SERVICE BULLETIN

NO. A6201-71-2

POWER PLANT - CORE COWLING - HOLD OPEN ROD
REPLACE COUPLEX LOCK, AND REPLACE DAMPER OR ADJUST UNIVERSAL
JOINT

FIGURE 1A - MINIMUM DISTANCE BETWEEN
UNIVERSAL AND OUTER TUBE

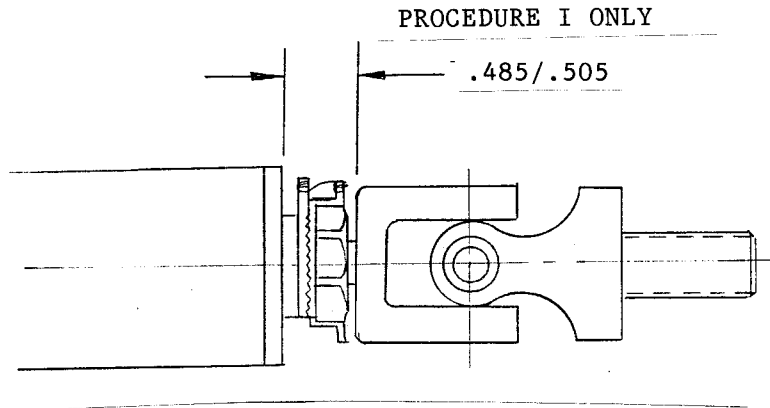
- (3) Check dimension between end of outer tube and face of universal as shown in Figure 1. Adjustment is necessary if dimension is less than 0.485 inches.

- (4) Adjust universal by cutting safety wire on lock washer and loosening jam nut. Pull lock washer back from face of outer tube to disengage locking tab. Adjust universal to the 0.485/.505 inch dimension shown in Figure 1A.

FIGURE 1B - OVERALL LENGTH

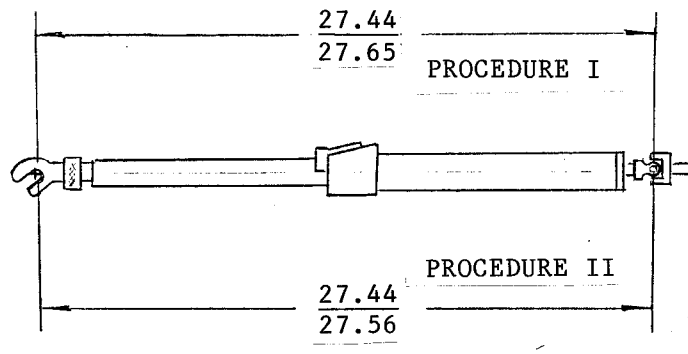
- (6) After adjustment check that the length of the rod is 27.44 to 27.65 inches extended and locked under compressive load. The length should be measured from the center of the universal pivot to the center of the coupler opening, per Figure 1B, Procedure I. If necessary, readjust the length by repositioning the universal assembly. Do not position the universal beyond the 0.485/.505 inch dimension shown in Figure 1A.

- (7) Screw universal assembly into outer tube end fitting and set the length of the rod to 27.44 to 27.56 inches extended and locked under compressive load. The length should be measured from the center of the universal pivot to the center of the couplex opening, per Figure 1B, Procedure II.

FIGURE 2 - A6201-3 END FITTING

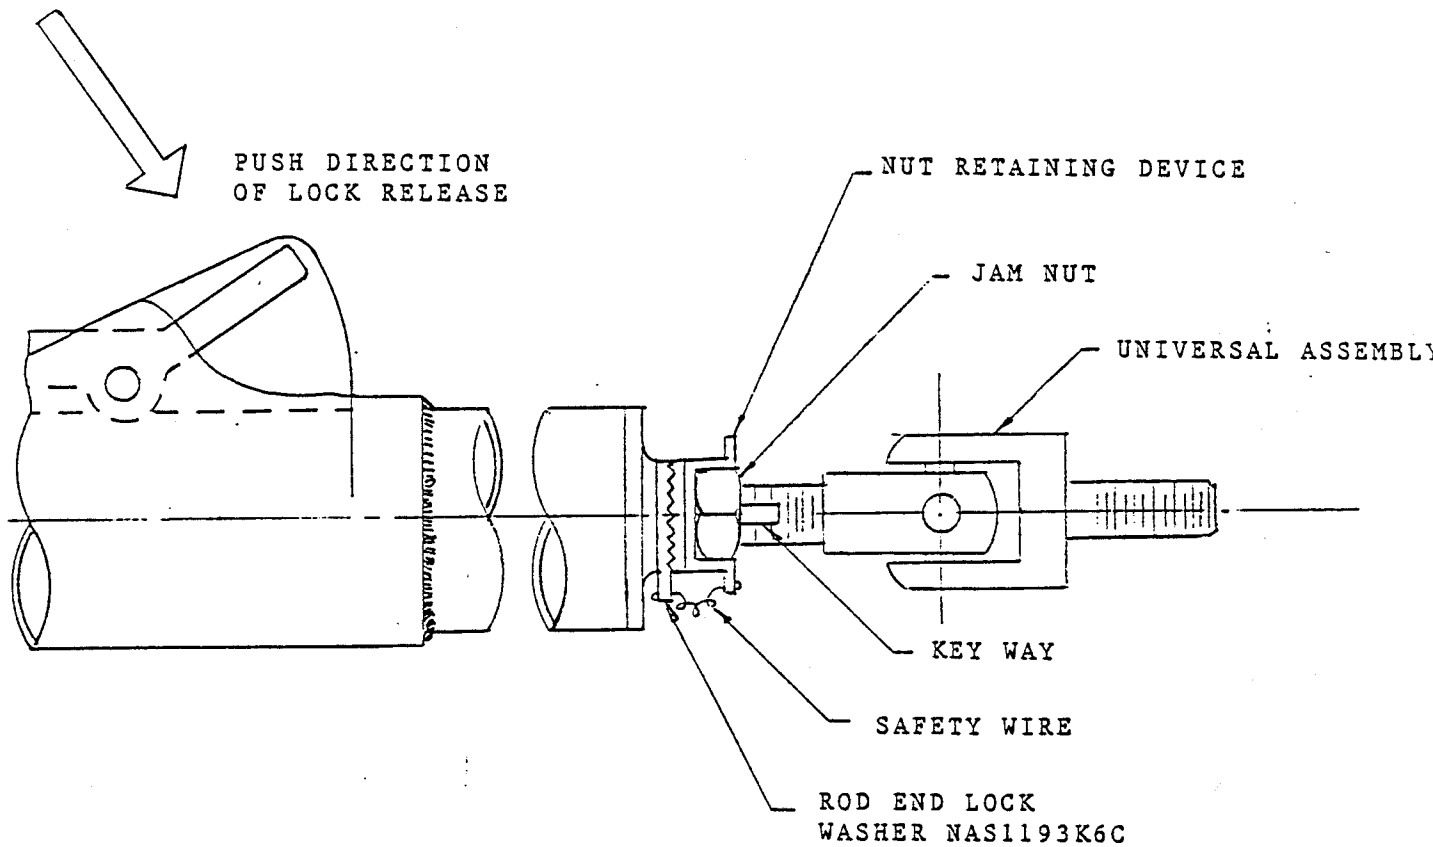
- (5) The A6201-3 rod requires adjusting the orientation of the universal keyway so that it is rotated 90 degrees from the push direction of the trigger lock release as shown in Figure 2. Tighten jam nut in the nut retaining device.

- (8) The A6201-3 rod requires adjusting the orientation of the universal keyway so that it is rotated 90 degrees from the push direction of the trigger lock release as shown in Figure 2. Tighten jam nut in the nut retaining device.

FIGURE 3 - STRUT ASSEMBLY MODIFICATION
A6201-2 AND -3 TO A6201-2C AND -3C
OR A6201-2D AND -3D

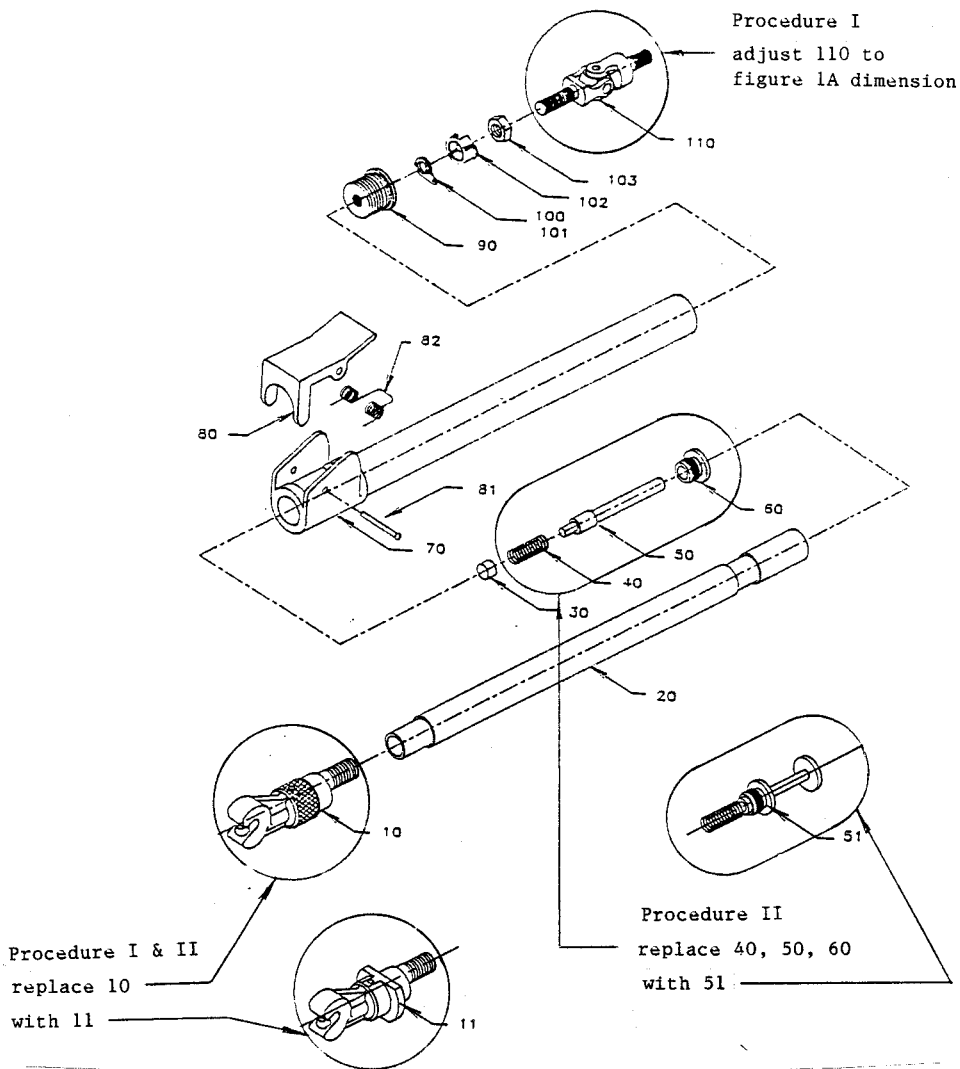
The following is a list of parts that should be discarded. Item numbers correspond to those shown in Figure 3.

<u>Item No.</u>	<u>Part Number</u>	<u>Description</u>	<u>Quantity</u>
10	CL6201-2	Couplex Lock	1
40	S355	Spring	1
50	AM6201-2-9	Pin-Damper	1
60	AM6201-2-30	End Fitting	1
